Recall Bulletin

PRODUCT SAFETY RECALL

SUBJECT: Harsh Transmission Shift, Engine Stall, Engine May Not Start, MIL or Service Engine Soon Lamp

MODELS: 2005-2008 Pontiac Vibe
Two Wheel Drive Equipped with 1.8L MFI Engine (LV6)

2530675

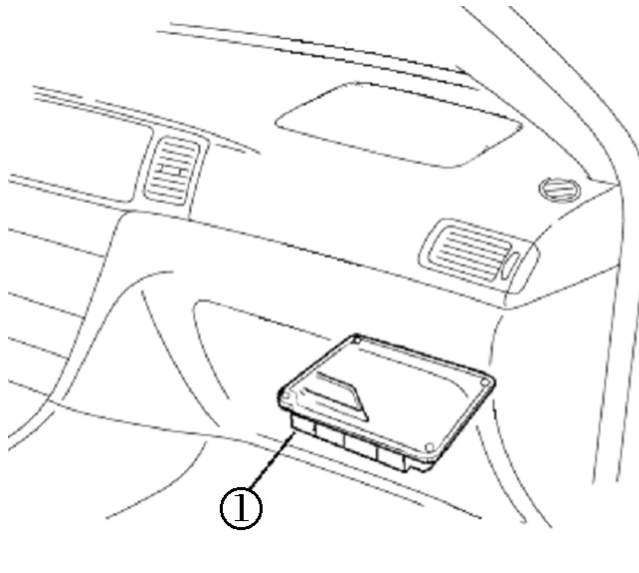
1. Locate the PCM (1) under the glove box compartment.
2. Record the part number (2) and the lot number (3) on the repair order.

Note: The pound sign (#) in the part numbers below represent digits (0-9) on the actual part installed in the vehicle. These parts will get a new PCM, according to the matrix.

3. Confirm the PCM part number to determine the required action using the table below.

4. Confirm the LOT number, if required. Determine the 9th through 12th digits as shown in the following example:

- If the LOT number is 7227 or higher, no further repair action is required. FOR CALIFORNIA VEHICLES ONLY: Install a Recall Identification Label and complete a "Proof of Correction" certificate upon recall completion.

- If the LOT number is 7226 or lower, replace the PCM. Refer to *PCM Replacement* in this bulletin.

1. Replace the PCM. Refer to *Powertrain Control Module Replacement* in SI.
2. Program the vehicle identification number (VIN) to the replacement PCM. Refer to *Control Module References* in SI.
3. FOR CALIFORNIA VEHICLES ONLY: Install a Recall Identification Label and complete a "Proof of Correction" certificate upon recall completion.
